OKTAVA MC-012/MK-012

NOTE: This is not an official Oktava schematic. It was reverse engineered from original circuit.

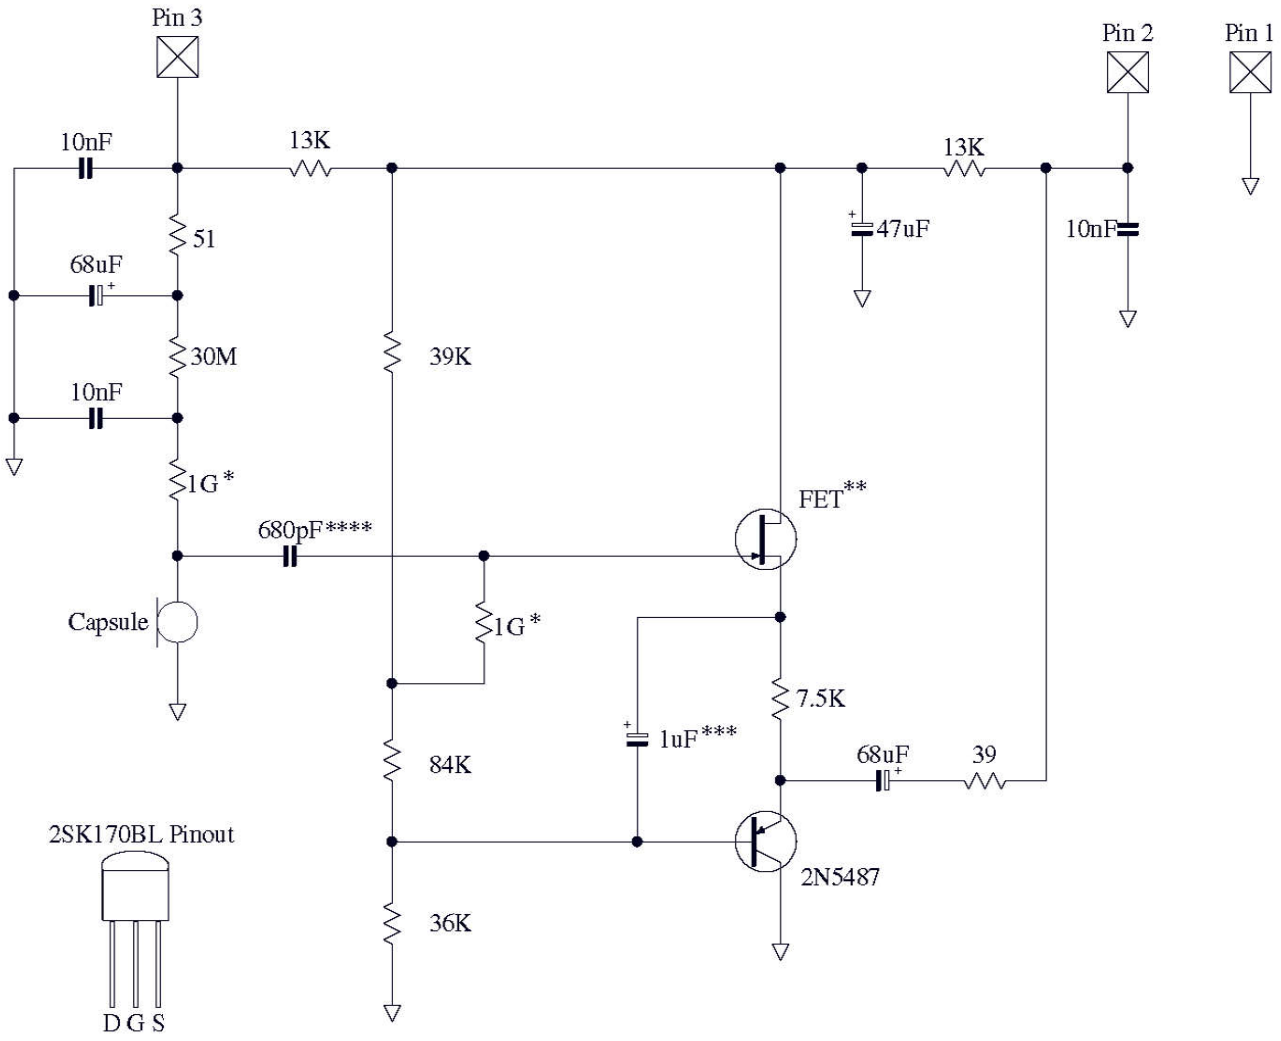
* Sometimes these are 680M - Change to 1G (680M looks like small capacitors - 1G looks like normal resistors)
** Change FET to 2SK170BL
*** Try 1uF film or 10/25 tant (or 10/25 electrolytic for really bright sound)
**** Try 820 or 1000pF polystyrene or polypropylene (or mica for really bright sound)
